Vermonters
for a
Clean Environment

RE: Draft Supplemental Information Report for the Deerfield Wind Project Final EIS

TO: Robert Bayer, Manchester Ranger District, GMNF
FROM: Kurt Frstrup, NPS Natural Sounds and Night Skies Division
Megan McKenna, NPS Natural Sounds and Night Skies Division
DATE: 26 February 2013
Re: Deerfield Wind Project, blade change request analysis

Subject: Draft Deerfield SIR

Visual Impact of Deerfield Wind Project on the Aiken Wilderness
Locations of photos taken from within the wilderness showing affected ridgelines

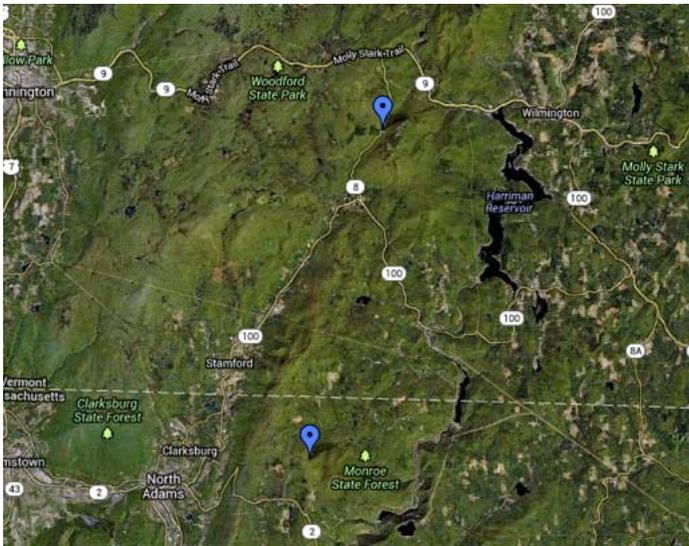
The USFS claims without evidence that the larger turbines will have no additional impact within the Aiken Wilderness, simply repeating the canard, utterly disproven by the photographs

submitted by VCE to the USFS during the administrative process, that people within the Aiken Wilderness will not notice the turbines.

Evidence provided previously by VCE, and reproduced in small part here, shows this contention to be completely false.⁶

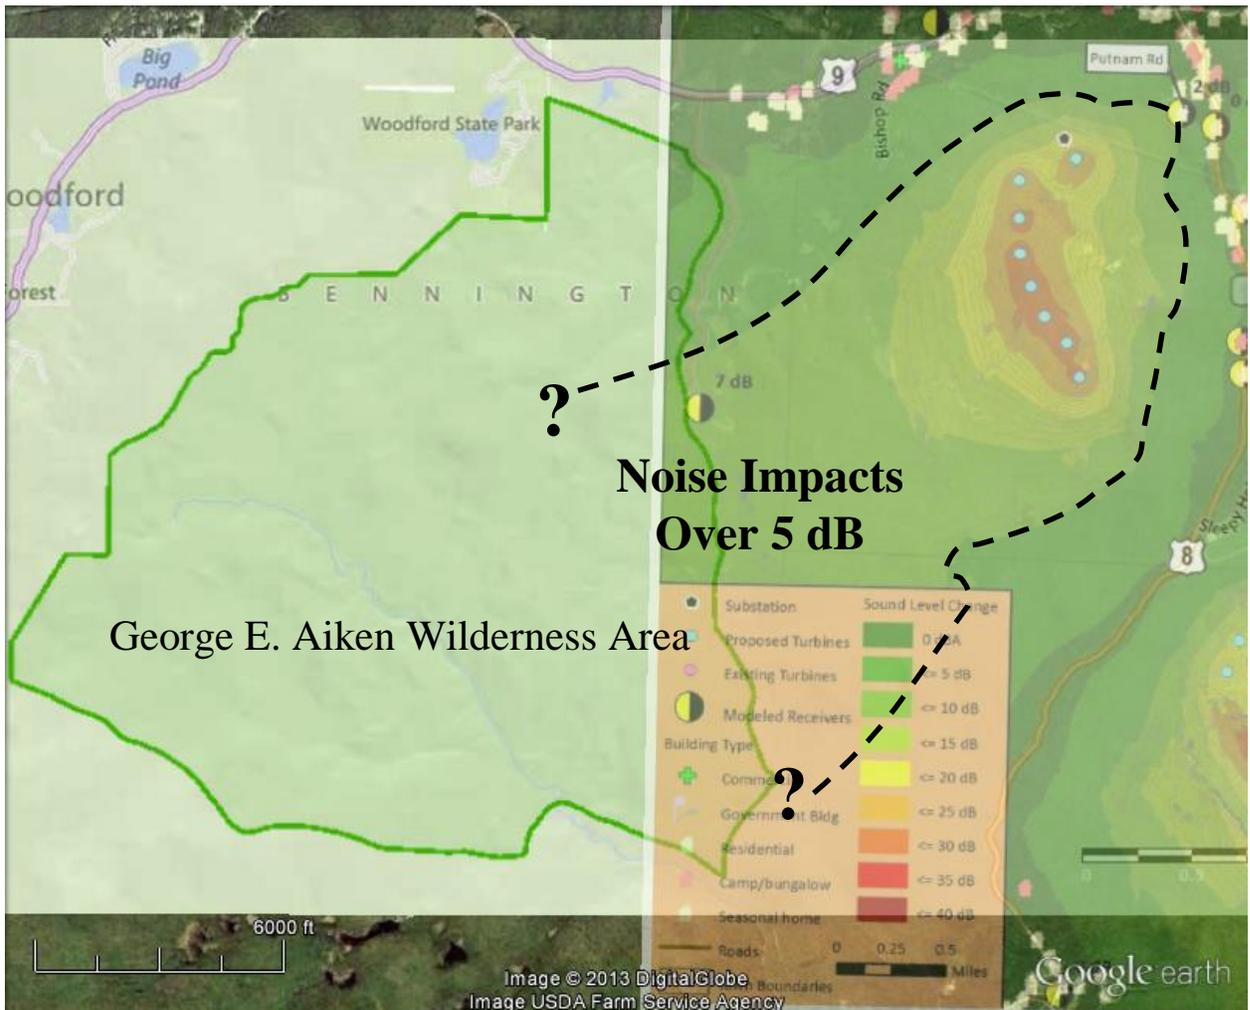
In fact, the RSG written reports did not include any detailed assessment of the impact on the aesthetics of the Aiken Wilderness, which should have been included given that the wilderness boundary is located only 1.3 miles west of the turbine locations. See Figure 1.

This omission is especially glaring when RSG's own predictions show a 7 dB increase at the Wilderness Area eastern boundary in the background 24-hour level, and a difference of 3 dB or *double the acoustic energy* compared to the 2007 prediction. Both results are clearly significant. So why did RSG find it unnecessary to investigate the impacts and predict noise levels and visitor noise reaction?

Figure 1. Predicted facility noise levels (RSG, 2012) impact wilderness area as much as 7 dB. RSG's figure legend obscured the extent of noise impacts into the Aiken Wilderness. The RSG figure did not show or quantify noise level changes in the Aiken Wilderness. Dashed lines and question marks on this figure infer and raise questions about the extent of total noise level changes over 5 dB, which is significant.

Figure 2. RSG's noise prediction for Deerfield appears to underpredict noise levels when compared to a similar ridge-line wind turbine project with smaller, lower sound power level turbines at Mars Hill [6].

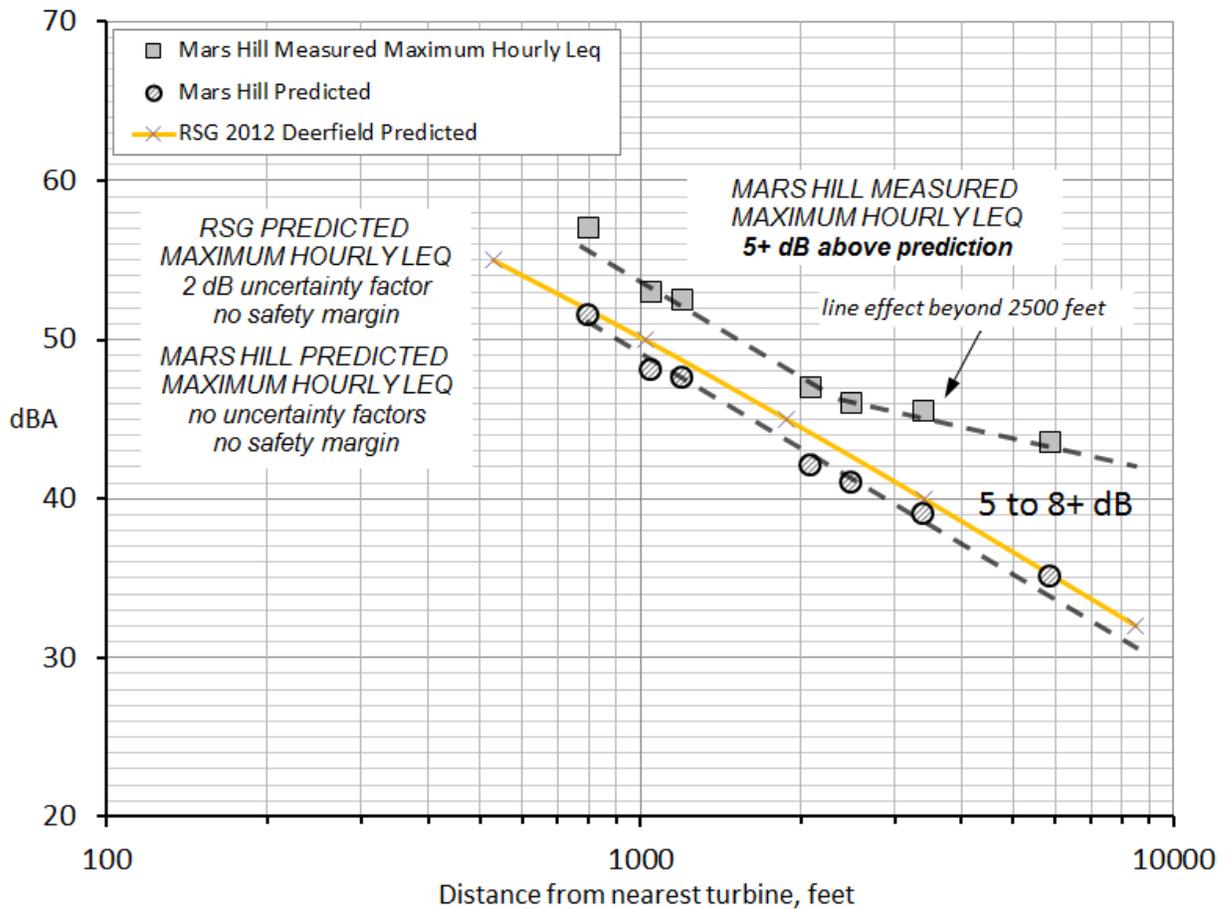
Review of the RSG model raises questions about its foundation. A similar ridge-top facility (Mars Hill, ME) measured 5 dB higher than predicted with no uncertainty factors. RSG used a 2 dB factor to account for the manufacturer's uncertainty margin. To match the 5 dB gap found at Mars Hill, RSG should have conservatively used an additional 3 dB uncertainty margin for a total of 5 dB. The under-prediction at Mars Hill is a strong indication that the RSG model could also under-predict actual average noise levels by 3 dB, and more beyond a 1/2 mile. No safety or design margin was used [5]. See Figure 2.
